Subject: CORROSION ON UPPER SHROUD CAUSING POOR APPEARANCE	Bulletin No: 09-043/14
	Last Issued: 10/10/2014

2013 CX-5 with VINs lower than JM3KE*****152861 (produced before Oct. 1, 2012)

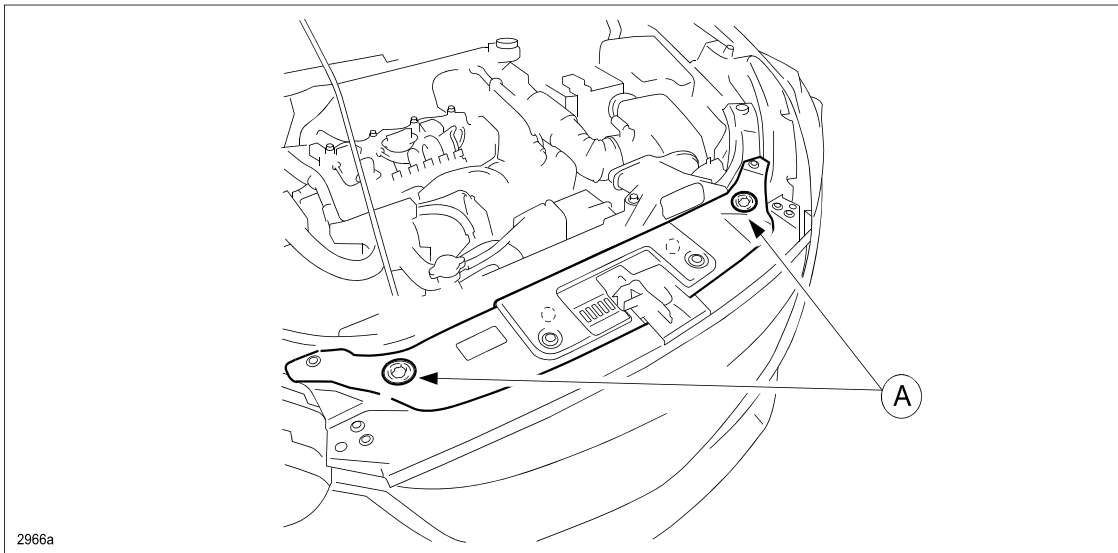
Some vehicles may exhibit corrosion on the upper shroud member where the hood stopper rubber makes contact (A). The paint surface is damaged by the hood stopper rubber, which causes corrosion and a poor appearance concern.

A protection seal has been attached to the upper shroud member to prevent paint damage.

REPAIR PROCEDURE

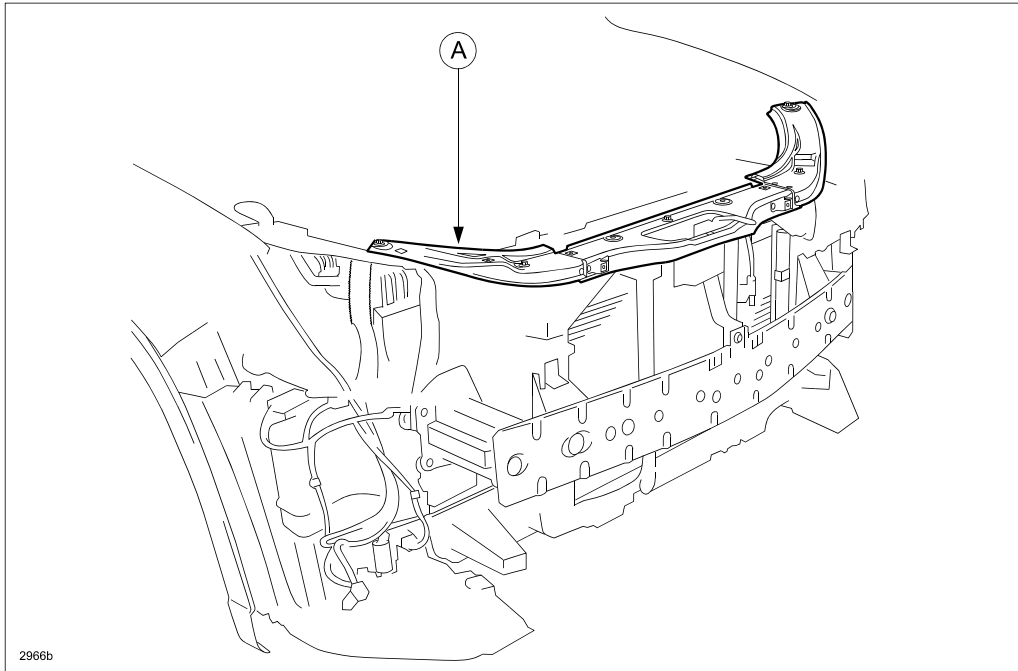
1. Open the hood and verify the customer concern.
2. Replace the upper shroud member (A) with a modified one (with protection seal) according to the instructions on MS3 online or the Workshop Manual (section 09-10 SHROUD UPPER MEMBER REMOVAL/INSTALLATION).
